DESCRIPTIVE REPORT

Registry No. H-10919

General Locality Southwest Prince William Sound

Sublocality Port Chalmers

Figure 5. Prior survey covering H10919 survey area.

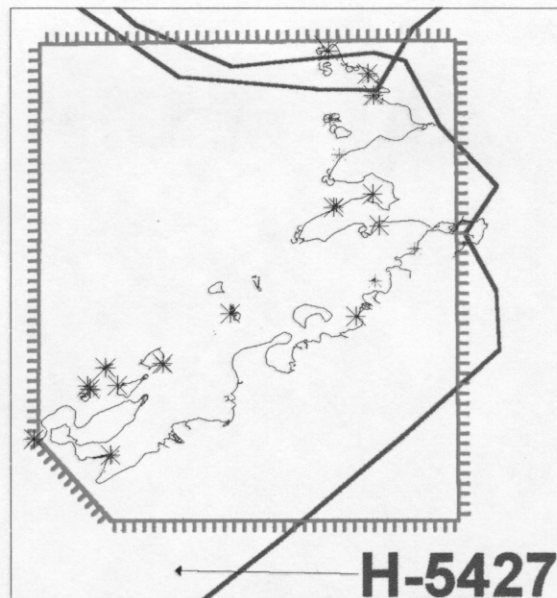
Prior survey H5427 covers the entire area of present survey H10919. The prior soundings were, for the most part, consistently ²⁻⁴₁₋₃ fathoms deeper. An exception is in the southwest cove of the survey area. This cove was inaccessible by a survey launch due to shoalness of area. In the vicinity, average depths were ³⁻¹⁰₂₋₅ fathoms shoaler than soundings from prior H5427. Similarly, the cove northeast of Port Chalmers was inaccessible by survey launches due to shoalness. *CONCUR*

Differences between the current survey and prior surveys can probably be attributed to scale and improved modern positioning and sounding equipment, along with changes caused by the 1964 earthquake. Final comparisons will be made at the Pacific Hydrographic Branch after application of smooth tides. CONCUR

Figure 7. AWOIS 52437

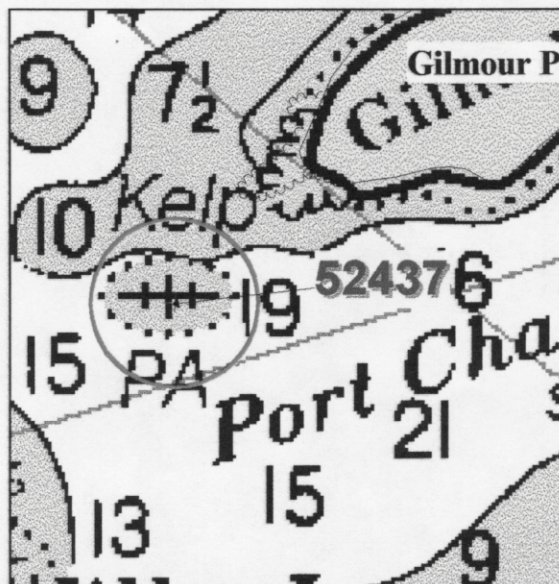
- 7. Comparison with the Chart and Charting Recommendation:**
AWOIS 52437 was compared to Chart 16700 (26th Ed.; September 19, 1998, 1:200,000), Chart 16701 (17th Ed.; July 25, 1998, 1:81,436), and Chart 16709 (21st Ed.; June 29, 1996, 1:80,000, 1:80,000). This item was not submitted as a Danger to Navigation. Figure 7 below depicts the wreck on chart 16709. ✓

The Hydrographer recommends removing the wreck symbol and charting soundings acquired by this survey.

CONCUR

Illustration 8. AWOIS 52438

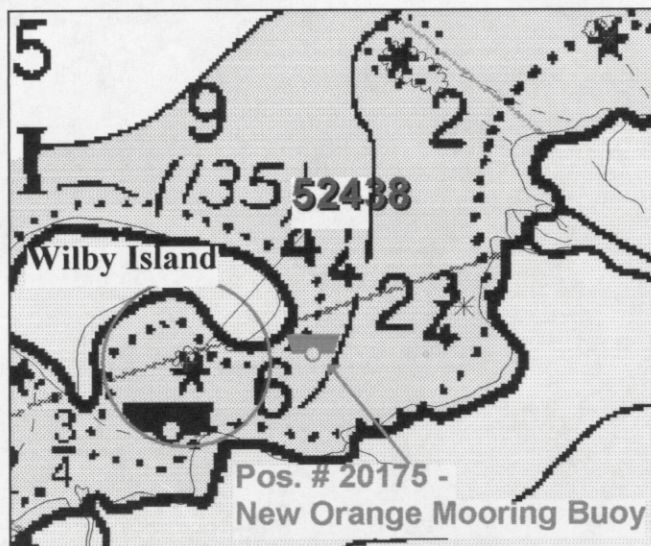
5. Results of Investigation: An orange mooring buoy was found ~~310 meters away~~ at 60°14'24.74"N, 147°12'53.17"W (see Pos. #20175). *Concur*

7. Comparison with the Chart and Charting Recommendation: AWOIS 52438 was compared to Chart 16700 (26th Ed.; September 19, 1998, 1:200,000), Chart 16701 (17th Ed.; July 25, 1998, 1:81,436), and Chart 16709 (21st Ed.; June 29, 1996, 1:80,000, 1:80,000). The mooring buoy was not charted on Chart 16700, but is charted on both Chart 16701 and 16709. This item was not submitted as a Danger to Navigation. Illustration 8 below depicts the charted mooring buoy and the position of the new mooring buoy (Pos. #20175 - in red).

The Hydrographer recommends changing the charted position of the mooring buoy to that acquired by the present survey. *Concur*
